UNITED STATES DEPARTMENT OF COMMERCE
Patent and Trademark Office

09/437,296 11/09/99 YAMAJI

Office Action Summary

DETAILED ACTION

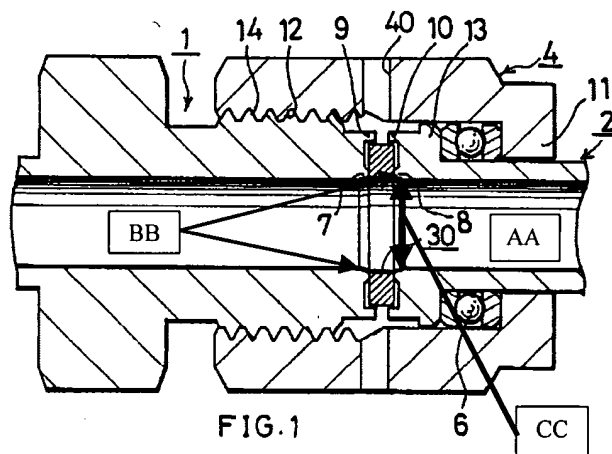
Claim 1 is rejected under 35 U.S.C. 103(a) as being unpatentable over US patent 6145888, Ohmi et al in view of US patent 6039319, Coonce et al. In figure 1 below,

Ohmi et al discloses a fluid

coupling comprising first and second coupling members (1, 2) having respective gasket holding annular ridges (7, 8) on butting end faces thereof, and an annular gasket (30) interposed between the two coupling members, the fluid coupling being characterized in that at least has a fluid channel (AA) comprising an opening passageway (CC) orthogonal to the butting end face thereof, and a slanting main passageway (BB) communicating therewith, the opening passageway having a diameter equal to the inside diameter of the annular ridge. Ohmi et al does not disclose the gasket having an

inside diameter smaller than the diameter of the opening passageway. Coonce et al teaches a gasket (38) having an inside diameter smaller than the diameter of the opening passageway (D1, D2) "to reduce fluid entrapment" (column 4, lines 66-67). It would have been obvious to one having ordinary skill in the art at the time the invention was made to fabricate the gasket with an inside diameter smaller than the diameter of the opening passageway to reduce fluid entrapment, as taught by Coonce et al.
